WRIGHT *Whirlwind* ENGINES

SERVICE BULLETINS

JANUARY, 1947

SUBJECT: Interference Between Valve Tappet Ball Socket and Guide

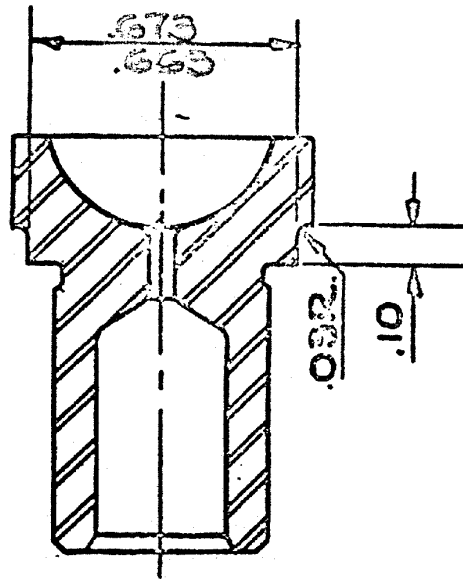
Several instances of interference between the shoulder on the valve tappet ball socket, Part No. 62728, and the tappet guide have been reported. Investigation has revealed that this condition is caused by bottoming of the valve tappet guide approximately .018 inch above the blueprint requirements, in crank-cases that have been machined to the high limit of production tolerances on the outside diameter. The interference may cause mutilation of the outer ends of the tappet guides.

To overcome interference at this point, a new valve tappet ball socket, Part No. 115176, has been designed with a .10 inch wide step in the shoulder to allow sufficient clearance between this part and the tappet guide.

It is recommended that all the above model engines which have not been overhauled be inspected at once or as soon as possible for signs of this trouble. Routine overhaul inspection of older engines should have revealed previously any interference which existed between these parts. To perform this check, remove the push rod, push rod housing, and tappet guide retaining nut. The condition of the end of the tappet guide may then be checked. Whenever this trouble is experienced, it is recommended that the new socket be installed or the old socket be reworked to incorporate the change.

FIG. 2

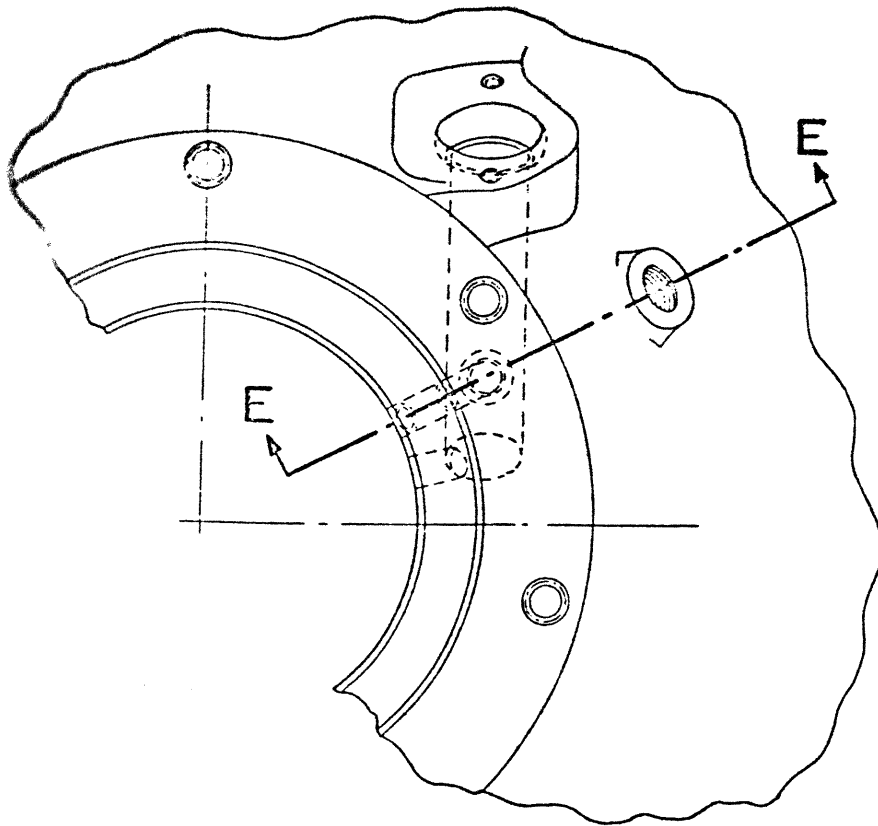
To install the external hydro oil line, it will be necessary to rework the inter-cylinder air deflector between cylinders, Nos. 8 and 9, in accordance with Figure 2. Insert the grommet, Part No. 2109-D-6, in the opening drilled in the air deflector. Install the deflector on the engine and insert the hydro oil tube in position through the grommet.

REWORK OF INTER-CYLINDER AIR DEFLECTOR
TO PROVIDE FOR EXTERNAL HYDRO OIL LINE

SB. NO. 539

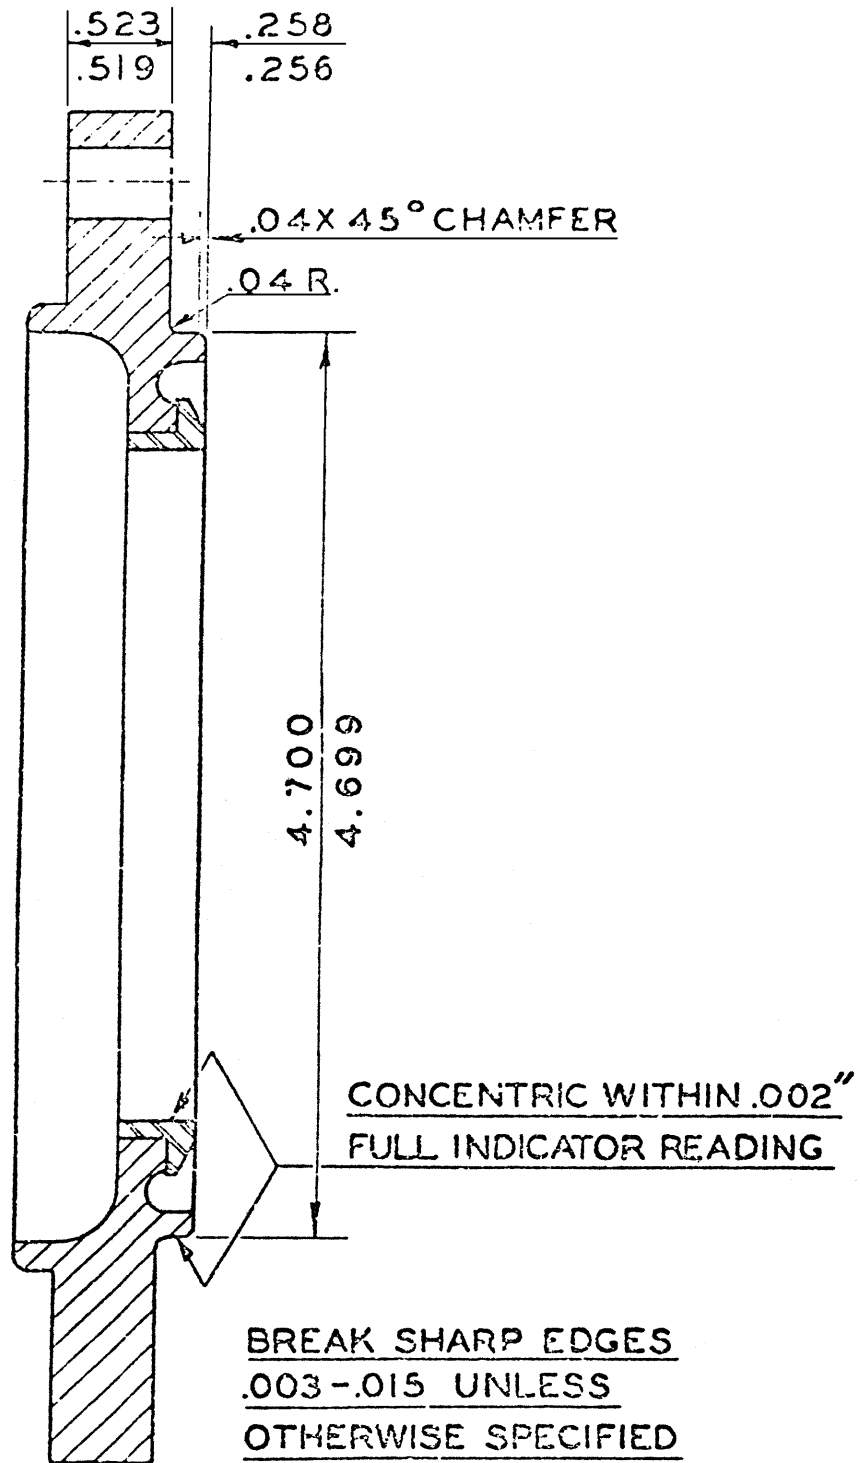
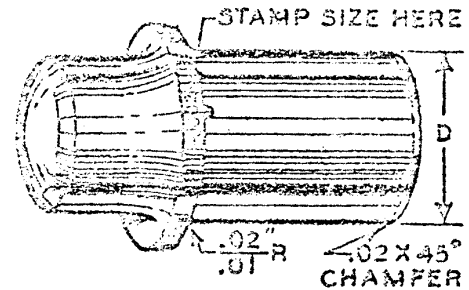
Whirlwind engines of current production have been provided with a steel crankcase front cover spacer, Part No. 114162, to eliminate galling between the front cover and the outer race of the thrust bearing.

A new front cover, Part No. 416337, is installed with the spacer in place of cover, Part No. 47170. The new cover and spacer together are approximately the same size and shape as the former cover alone. The .005-.007 inch tight fit between the bearing and front cover has been changed to a .002-.004 inch loose fit when the spacer is used.

It is recommended that Whirlwind operators incorporate this spacer on engines in which galling of the front cover or thrust bearing is experienced. The crankcase front cover, Part No. 47170, may be replaced or may be reworked for use with the spacer.

Rework of the front cover, which is made of aluminum, may be accomplished with an ordinary lathe operation. Reduce the width of the cover to .519-.523 inch as shown in the sketch at the end of this bulletin, removing the metal from the rear face. Reduce the outer diameter of the cover pilot flange to 4.699-4.700 inch. Provide a .040 inch radius in the corner between the two reworked surfaces. Shorten the pilot flange to .256-.258 inch and provide a .040 inch 45 degree chamfer on the outer diameter at the end of the flange. Break all sharp edges to a .003-.015 inch radius.

SERVICE BULLETIN NO. 592

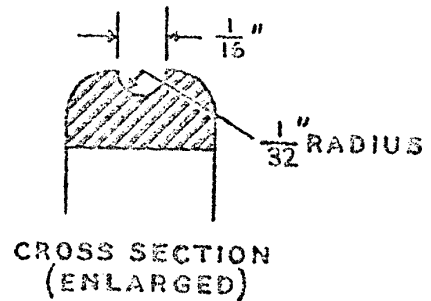
A change has been made in the design of the oil seal packing, Part No. 2083-D-25, located at the diffuser section parting surfaces on the main pressure oil passage.

A groove has been cut in the ring to provide room for displacement of the ring material when the engine sections are assembled. With an ungrooved ring if the material more than fills the space provided for it, the excess may become wedged between the parting surfaces and may possibly crack the crankcase when the attaching bolts are tightened.

Figure 1

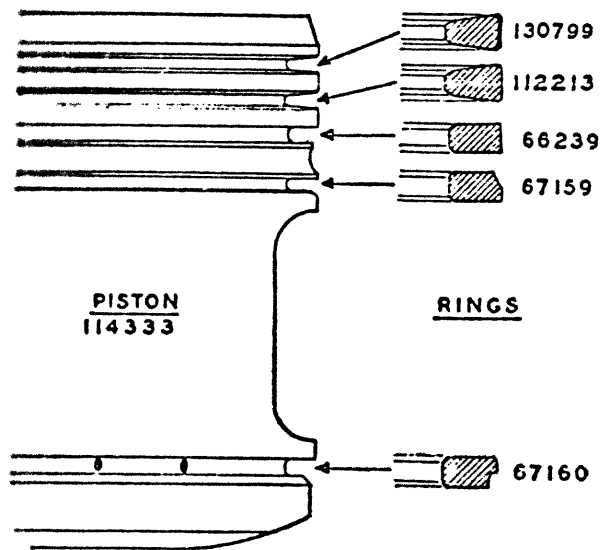
Piston, part No. 114333, is being installed in all R-760E and R-975E engines. This piston incorporates 12 oil drain holes in the No. 5 ring groove and employs a new chrome faced piston ring, part No. 130799, in the No. 1 ring groove. See figure 1. Rings, part No. 112213, 66239, 67159, and 67160, are used in ring grooves No. 2, 3, 4, and 5 respectively. This arrangement greatly improves oil control which in turn insures longer service from the piston and the piston rings.

Piston, part No. 112214, formerly installed in these engines, incorporated oil drain holes in ring groove No. 4 and in the land between grooves No. 3 and 4. Ring, part No. 112213, was installed in ring grooves No. 1 and 2 and ring, part No. 66239, was installed in grooves No. 3, 4, and 5.

Piston, part No. 112214, may be reworked in accordance with instructions contained herein and used satisfactorily with the ring set up shown in figure 1.

Figure 2

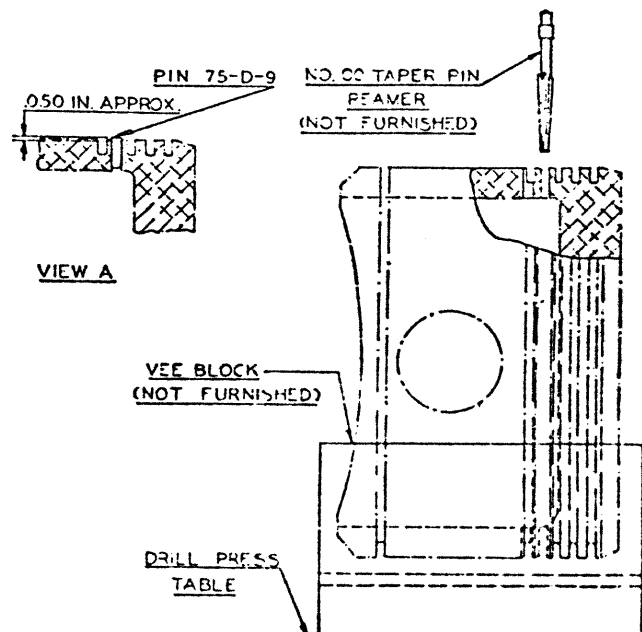
(a) Place the piston on a vee block on a drill press table as shown in figure 2. Insert a No. 00 taper pin reamer in the drill chuck and ream the first hole until the large end of pin, part No. 75D9, when inserted, will project approximately .050 inch above the bottom of the land, as shown in View "A." Set the stop of the drill spindle for the proper reaming fit. Ream the remaining holes on the land.

Figure 3

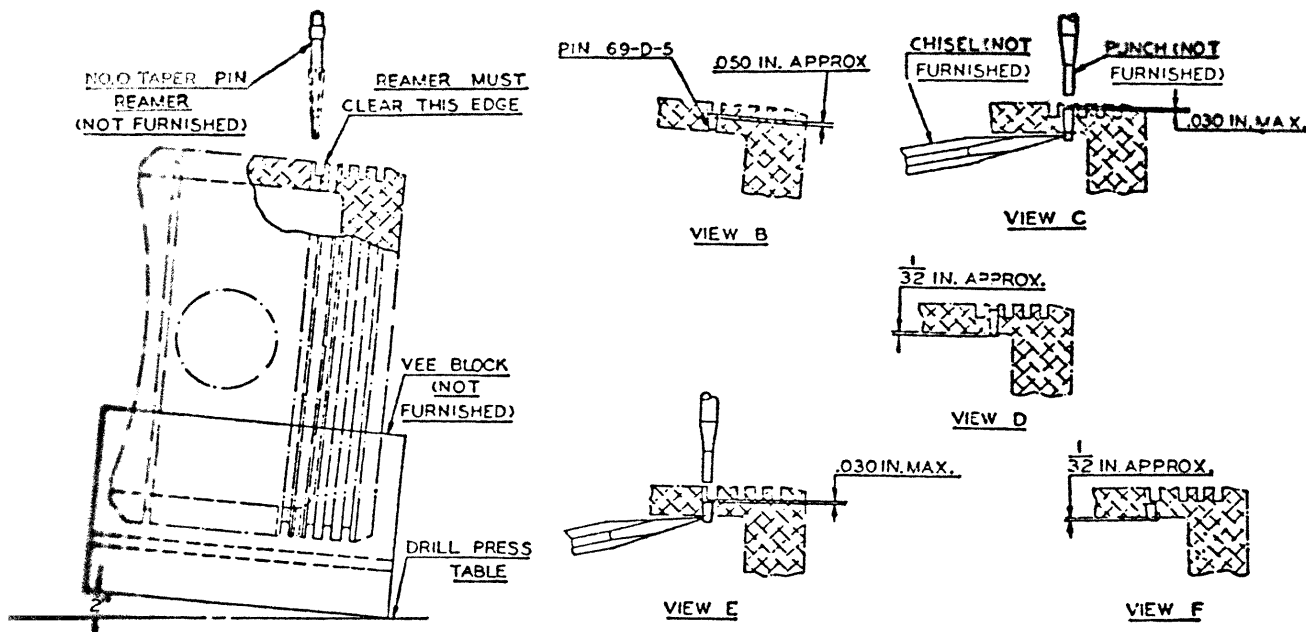
(b) Place the piston on a vee block as shown in figure 3, with the block shimmed to approximately 2 degrees. Insert a No. 0 taper pin reamer in the drill chuck and ream the first hole in groove No. 1 until the large end of pin, part No. 69105, when inserted, will project approximately .050 inch above the bot-

tom of the groove, as shown in View "B." Set the stop on the drill spindle for the proper reaming fit. Ream the remaining holes in groove No. 4.

Figure 4

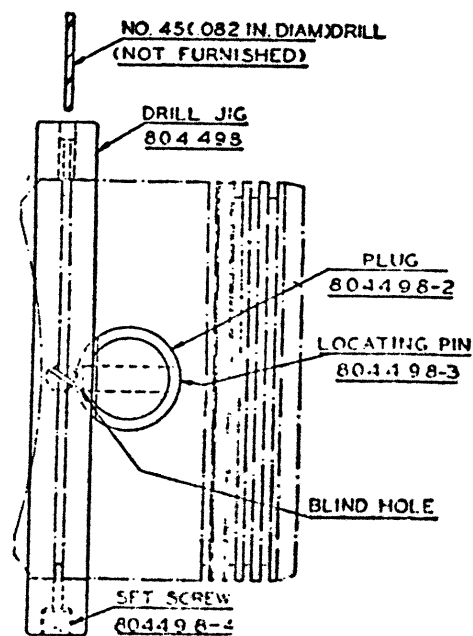
(a) Insert plug, tool No. 804498-2, in the piston pin hole, and slip drill jig, tool No. 804498, over the lower end of the piston and locate the blind hole in the jig with the pin in the plug. Insert the shank of a No. 45 (.082 inch diameter) drill through one of the drill bushings and into the lower groove of the pistons. Engage the pilot end of the four screws in this groove using care so that the screws are not forced against the piston. Remove the drill. Place the jig on a vee block. Drill 12 holes through using a No. 45 (.082 inch diameter) drill. Remove the burrs. See figure 4.

Figure 5

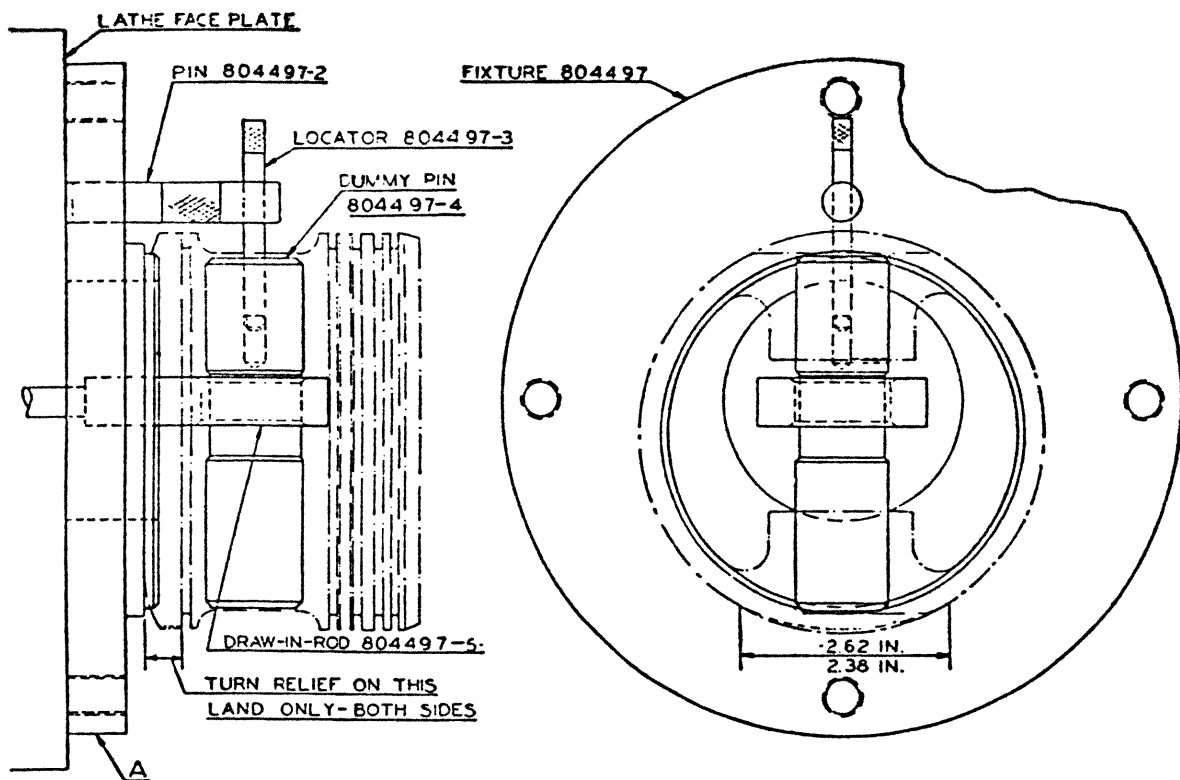
(a) Clamp the fixture, tool No. 804497, to the lathe plate. Indicate at "A" to run true within .001 inch full indicator reading. Place the piston on the fixture and insert a dummy pin, tool No. 804497-4, through the piston and the draw rod and tighten the

nut on the draw rod lightly. Locate the piston radially on the fixture using pin, tool No. 804497-2, and locator, tool No. 804497-3, as shown in figure 5. Clamp the piston to the fixture securely by tightening the draw rod nut. Cut the relief to the dimensions shown. Repeat this operation on the opposite side of the pistons. Break all sharp corners. See figure 5.

Figure 6

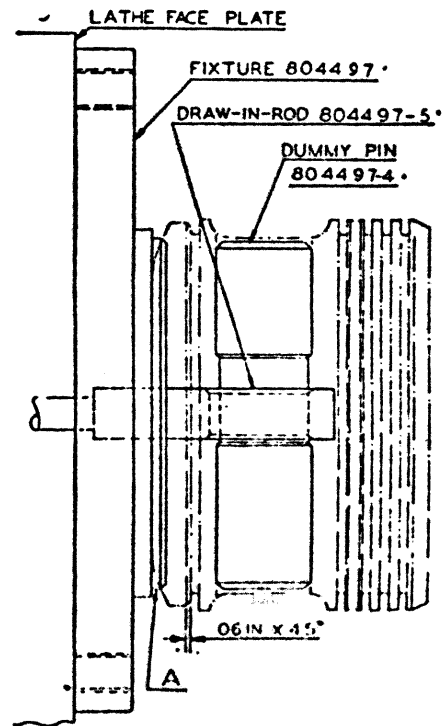
(a) Clamp the fixture, tool No. 804497, to the lathe face plate, indicating surface "A" to run true within .001 inch full indicator reading. Clamp the piston to the fixture using the dummy piston pin and draw-in rod as shown. Cut chamfer to the dimensions shown. Break all sharp corners. See figure 6.

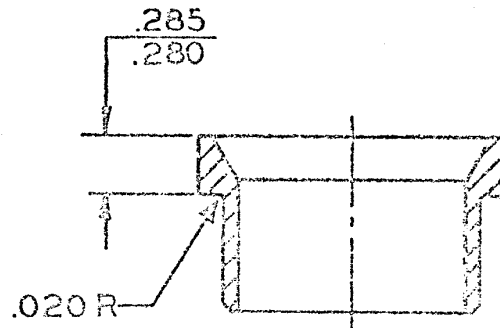
A new duprene oil seal, part No. 2083D30, has been designed to replace the cork seal, part No. 23480, which, in a few instances, has caused leakage of oil into the diffuser section. This leakage was the result of a permanent set taken by the cork after a few hours of engine operation.

At next overhaul, install the new oil seal, part No. 2083D30. This cannot be done, however, without replacing the retainer, part No. 23484, with part No. 114732. If it is desired, part No. 23484 may be reworked to the dimensions of part No. 114732 and installed satisfactorily with the new oil seal.

Shorten the flange of part No. 23484 to the dimensions given. See figure 1.

Figure 1

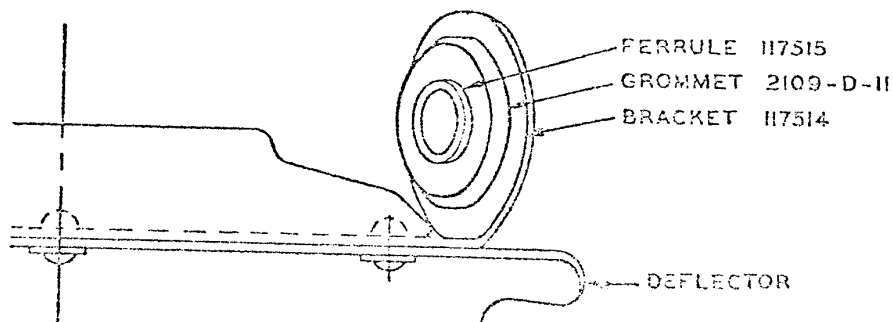
1. Replace the present bracket with the bracket assembly sketched in figure 1. Attach the brackets to the deflector with three 1/8 inch rivets, part No. 66D19, and washers, part No. 27D130.

Figure 2

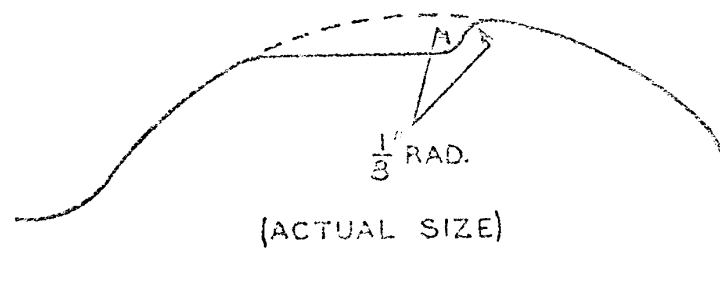
2. To provide clearance for the new bracket, profile the first cooling fin below the attaching screw boss on the exhaust side as shown in figure 2. Break and blend all sharp edges.
